STATE OF CONNECTICUT
CONNECTICUT SITING COUNCIL

IN RE: :
 :
APPLICATION OF CELLCO PARTNERSHIP : DOCKET NO. 372
D/B/A VERIZON WIRELESS FOR A :
CERTIFICATE OF ENVIRONMENTAL :
COMPATIBILITY AND PUBLIC NEED FOR :
THE CONSTRUCTION, MAINTENANCE :
AND OPERATION OF A WIRELESS :
TELECOMMUNICATIONS FACILITY AT :
631 ORANGE AVENUE, MILFORD, :
CONNECTICUT : JANUARY 27, 2009

RESPONSES OF CELLCO PARTNERSHIP D/B/A VERIZON WIRELESS
TO CONNECTICUT SITING COUNCIL PRE-HEARING INTERROGATORIES, SET ONE

**Docket No. 372
 Response To Connecticut Siting Council Interrogatory Question 8
 Existing Verizon Wireless PCS Coverage
 With Proposed Milford East Facility At 100 Feet AGL**

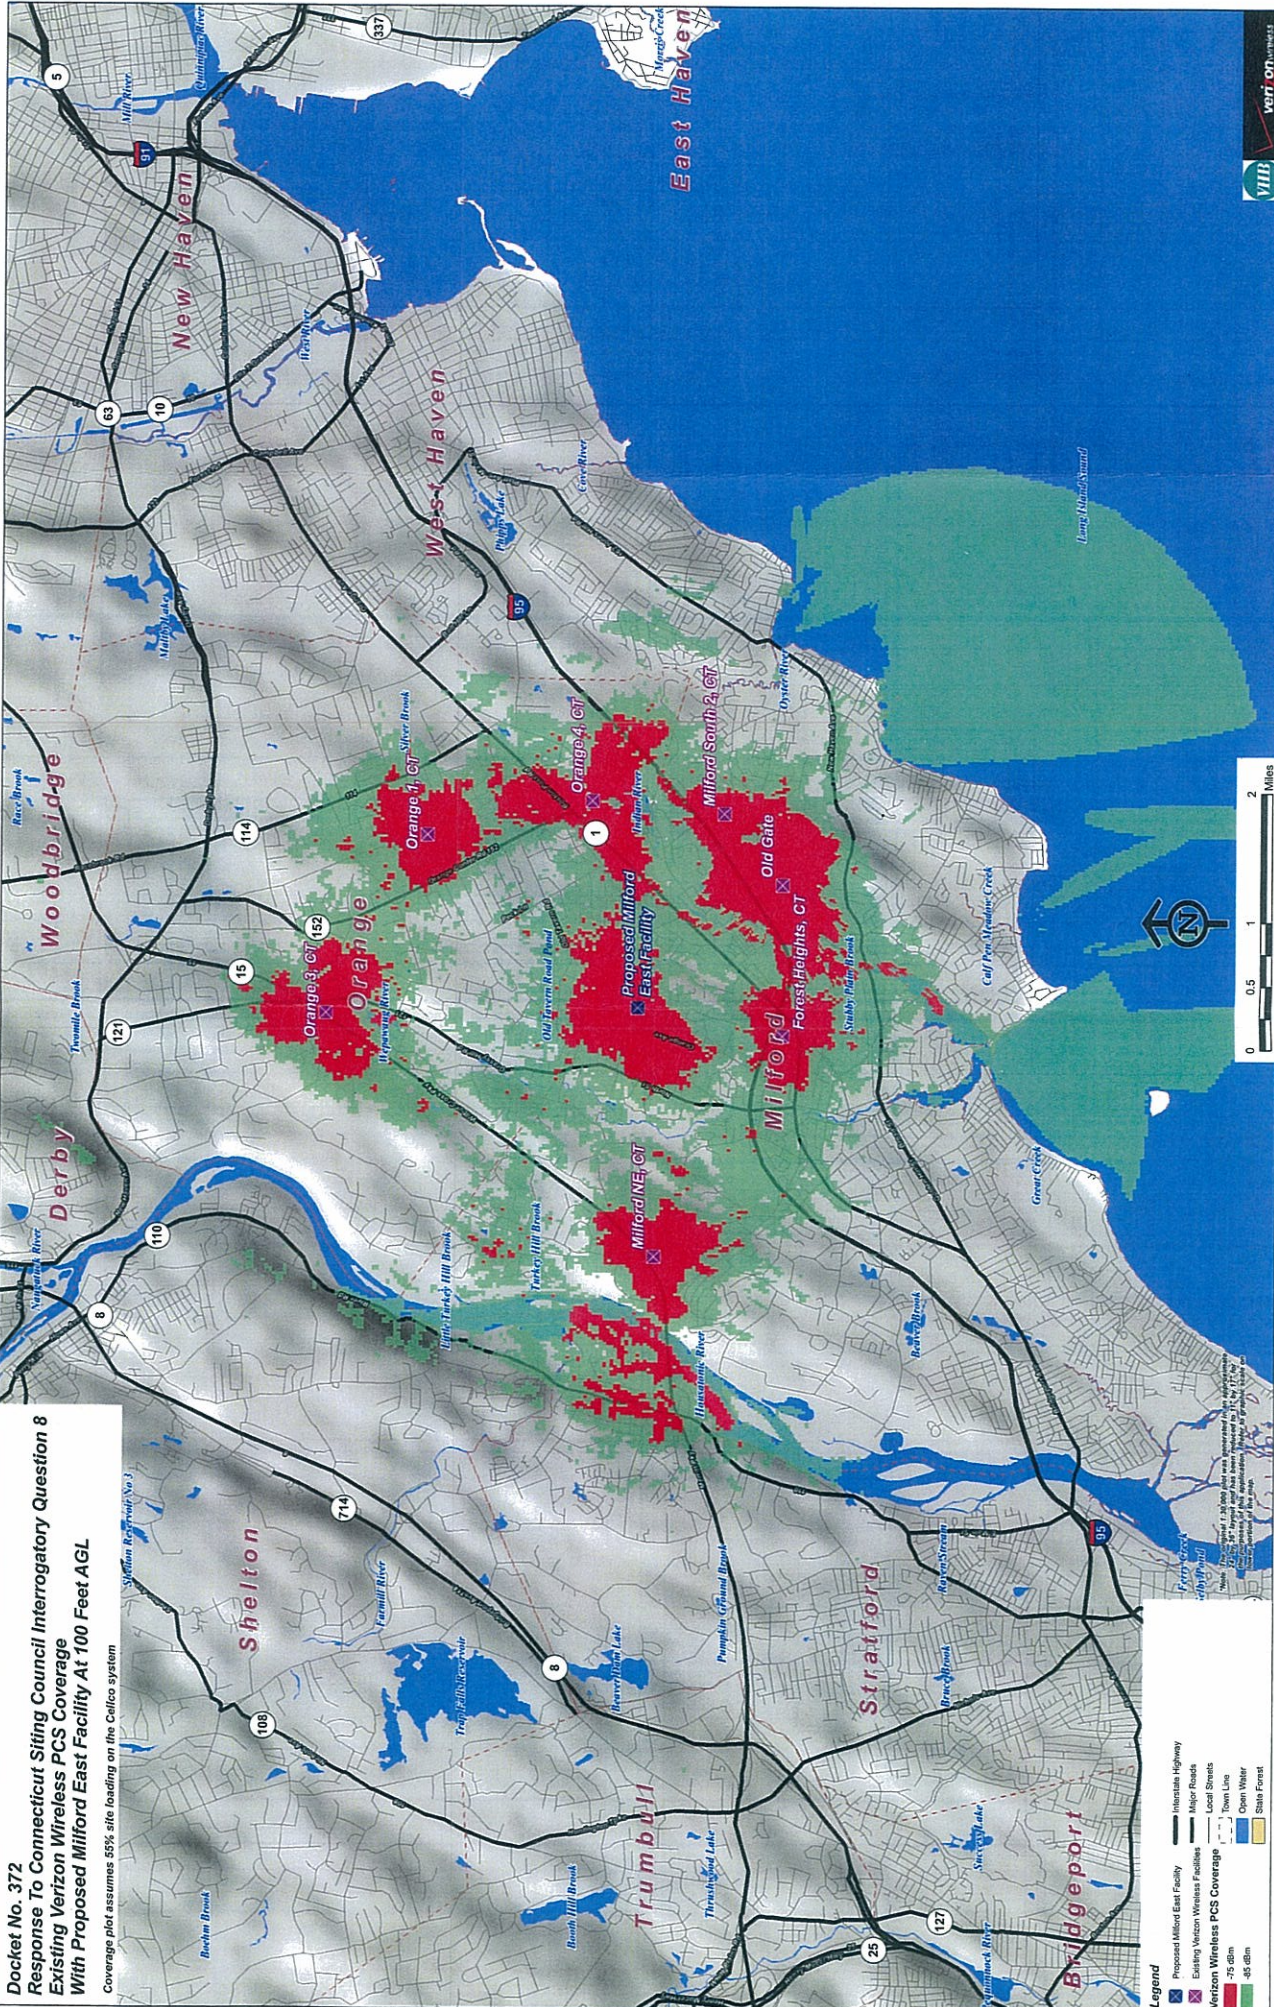
What is the lowest height at which Cellco's antennas could achieve its coverage objectives from this site? Submit propagation maps showing the coverage at ten feet below this height.

Cellco's antennas must be located at the 110-foot level to achieve its PCS coverage objectives in the northern portion of Milford. Composite coverage plots showing Cellco's existing and proposed PCS and cellular coverage with the Milford East antennas at 100 feet, ten feet below the proposed antenna height, are included in Attachment 1.

**Docket No. 372
 Response To Connecticut Siting Council Interrogatory Question 9
 Cellular Coverage From Proposed Milford East Facility
 At 110 Feet AGL**

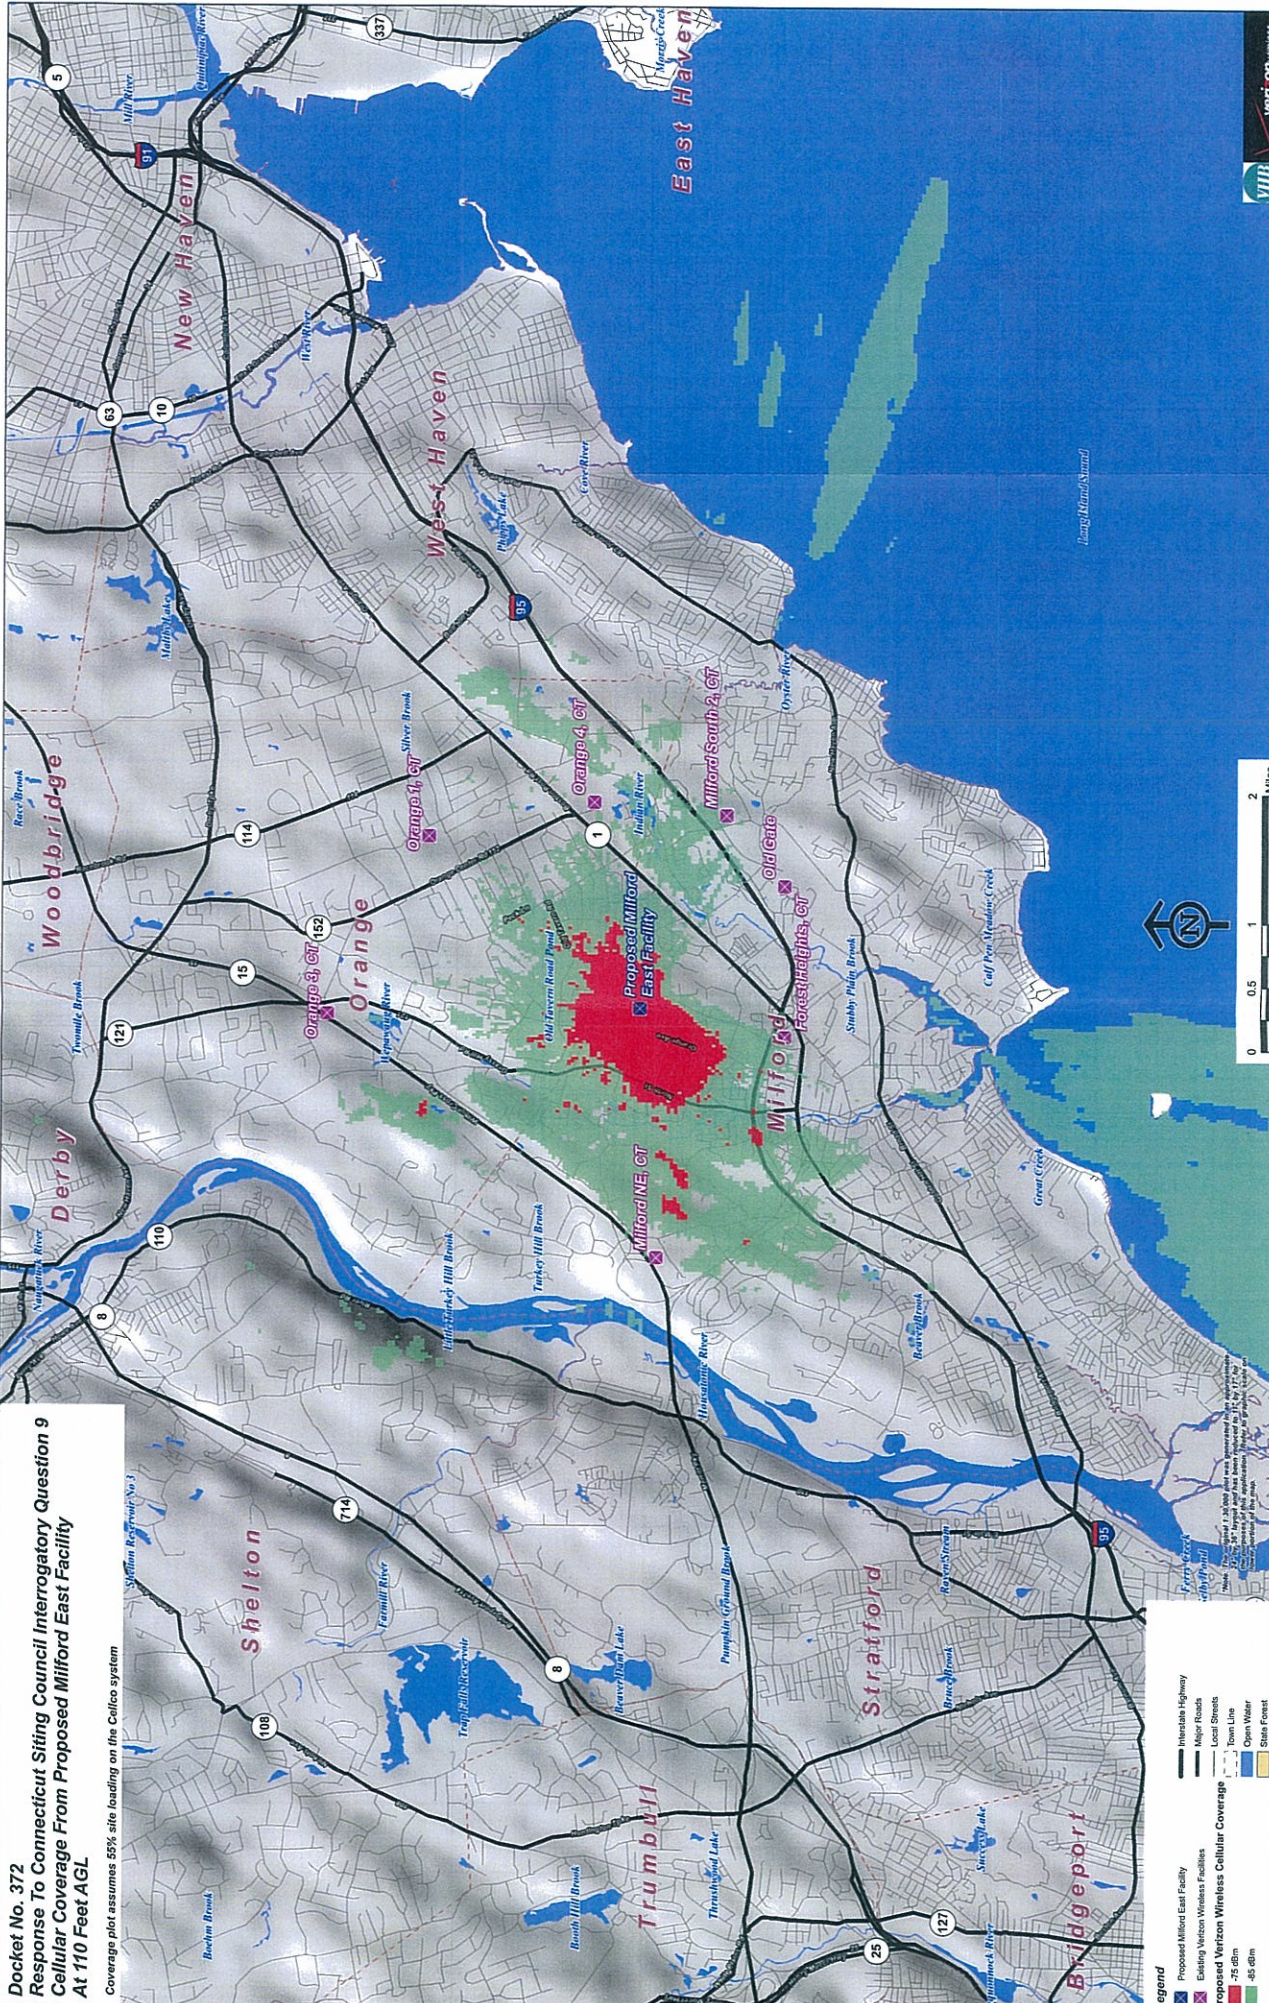
Provide propagation maps showing only the PCS and cellular coverages from the proposed site.

The coverage maps requested are included in Attachment 2. The Council may notice that the coverage footprint for the PCS and cellular systems shown on these "stand-alone" plots are substantially similar. Normally, the Council would expect to see the coverage footprint for cellular to be substantially larger than the PCS coverage footprint. The cellular plot included in Attachment 2 however, takes into consideration Cellco's plans to "down-tilt" the cellular antennas at this site. By doing so, Cellco can limit the cellular coverage footprint from this site and avoid potential interference and redundancy problems that might otherwise result from the proposed Milford East cell site.
